ADDENDUM NO. 2

BID TITLE: Tequesta Trace Artificial Turf Fields (Synthetic Grass Replacement)

BID NO: 2026-07

DATE: May 12, 2026

DETAILS

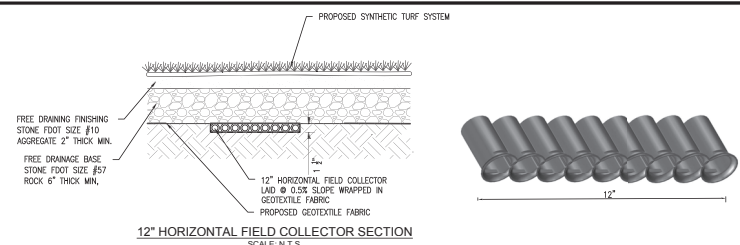
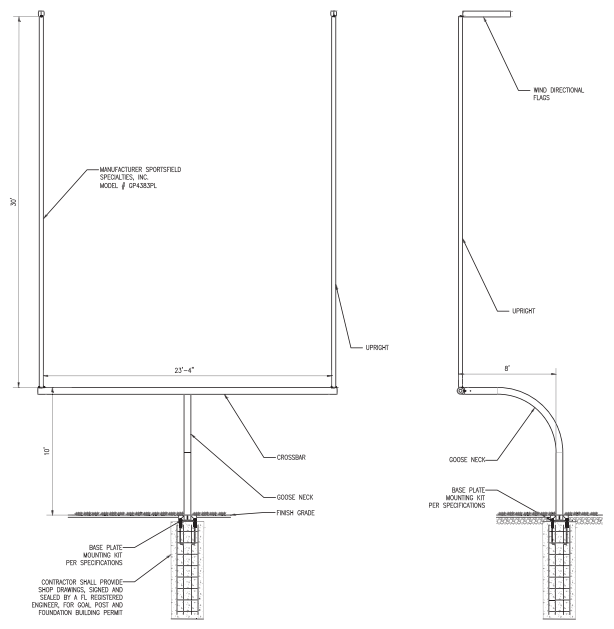
3) Q: Could you provide a section showing the existing artificial turf with the base and sub-base?

29) Q: Since there is a line item for removing roots, what are the existing soils like below the turf construction? Please provide a report on the existing soils.

33) Q: Sheet C1 “Record Drainage Plan for Reference Only” does not include the cross-section of the exfiltration or a detail for the lateral. Please provide

A: See attached Sheet C2 from original project plans.

A: Refer to attached Sheet C2 from the original project plans for details

A: See response to Question #29, above.
